Access Compliance Report

Public Rights-of-Way

Intersection ID: 42551	Main Street: ENEIDA_SUE_DR	Cross Street: HANNAH_RAE_CT	Location: NW
ADA ID: 43FB1C8AC5FA	Ramp Type: PerpDiag	Initial Pass/Fail: Fail	Overall Compliance: No
			Severity Score: 33.75

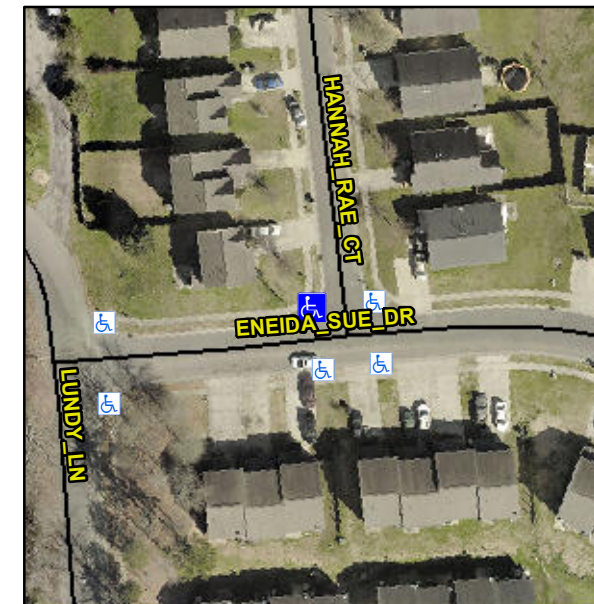
Not Found, R304.5.1, R304.5.3

Compliance	Description	Data	Compliance	Description	Data
N/A	Ramp Length (in)	47.5	Yes	Ramp Slope (%)	5.2
No	Ramp Width (in)	39.0	No	Ramp XSlope (%)	9.0
N/A	Flare Type LT	N/A	N/A	Flare Type RT	N/A
N/A	Flare Slope LT (%)	N/A	N/A	Flare Slope RT (%)	N/A
N/A	Flare Traversable LT?	N/A	N/A	Flare Traversable RT?	N/A
N/A	Landing Length (in)	N/A	N/A	DWS Provided?	N/A
N/A	Landing Width (in)	N/A	N/A	DWS Contrast?	N/A
N/A	Landing Slope (%)	N/A	N/A	DWS Length (in)	N/A
N/A	Landing X Slope (%)	N/A	N/A	DWS Full Width?	N/A
N/A	Landing Curb? (Y/N)	N/A	N/A	DWS Offset (in)	N/A
N/A	Shared Landing?	N/A			
N/A	Gutter Ponding?	N/A	N/A	Gutter Slope (%)	N/A
N/A	Gutter Lip Ht (in)	N/A	N/A	Gutter X Slope (%)	N/A
N/A	Painted X Walk1?	No	N/A	Painted X Walk2?	No
	X Walk 1 Direction	To S		X Walk 2 Direction	To E
N/A	X Walk 1 Width (in)	N/A	N/A	X Walk 2 Width (in)	N/A
	X Walk 1 Slope (%)	3.5		X Walk 2 Slope (%)	10.0
	X Walk 1 X Slope (%)	9.1		X Walk 2 X Slope (%)	1.5

Remove & Replace Curb Ramp With Two New Directional Ramps or Equivalent.
